**Field-Truthing and Monitoring of the Proposed PennEast Pipeline,  
FERC Draft EIS, Docket No. CP15-558**

September, 2016

Prepared by: Delaware Riverkeeper Network

**Figure 31.** Locations of temperature readings taken on existing Buckeye ROW and from distances away from ROW to illustrate forest fragmentation and thermal impacts. Note Blue Mountain Ski area also to the right frame of the photo.

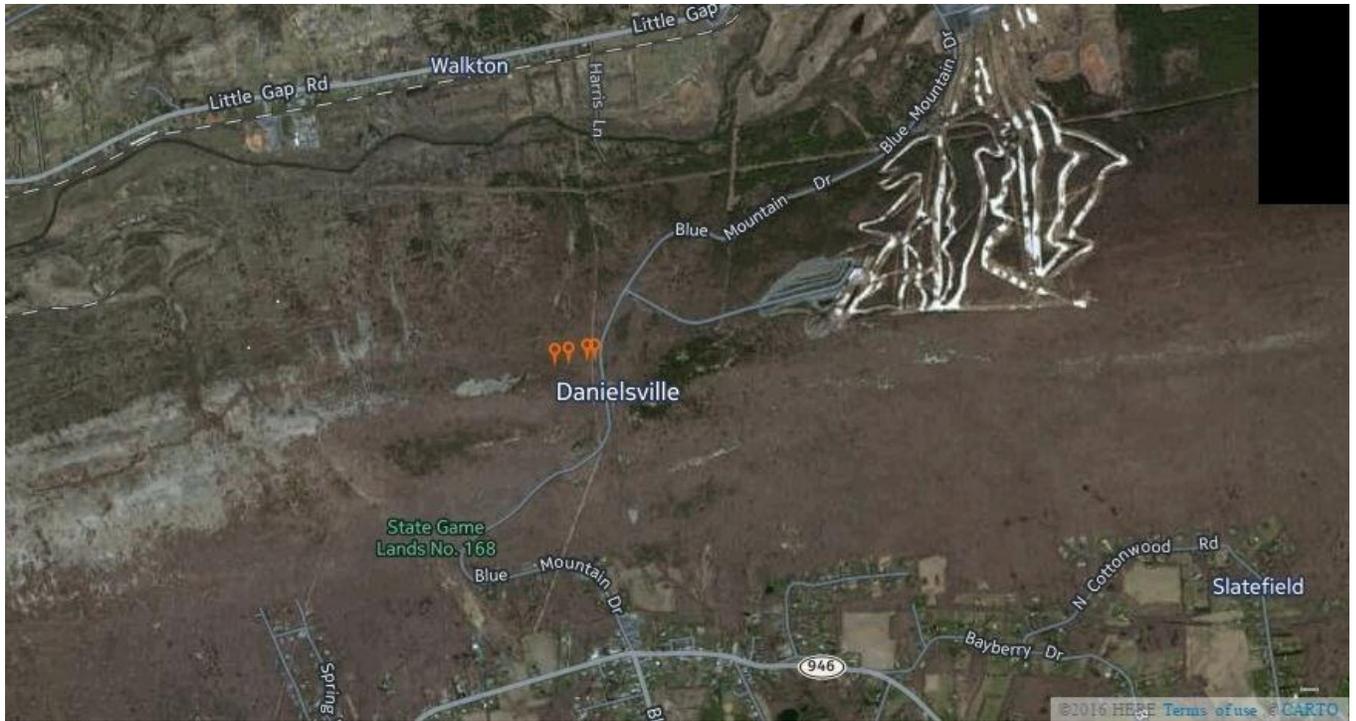
DRN conducted a snapshot temperature study along the existing Buckeye oil gas transmission ROW that is west of the proposed Penn East ROW. DRN used a Lamotte calibrated thermometer to record air temperatures at four locations on or adjacent the existing pipeline route. It is logical to assume that much of the long term impacts on the Buckeye Route in this reach on Blue Mountain would be similar impacts for the proposed PE route.

DRN recorded extreme temperatures on the existing ROW and temperature impacts that continued into the forest and away from the ROW for over 615 feet. These forest impacts are also cited in the literature and expert reports submitted authored by Kevin Heatley. The distance an edge effect extends into a forest/woodland is variable, but most studies point to at least 300 feet (Rodewald 2001; Ontario Ministry of Natural Resources 2000; Robbins 1988;
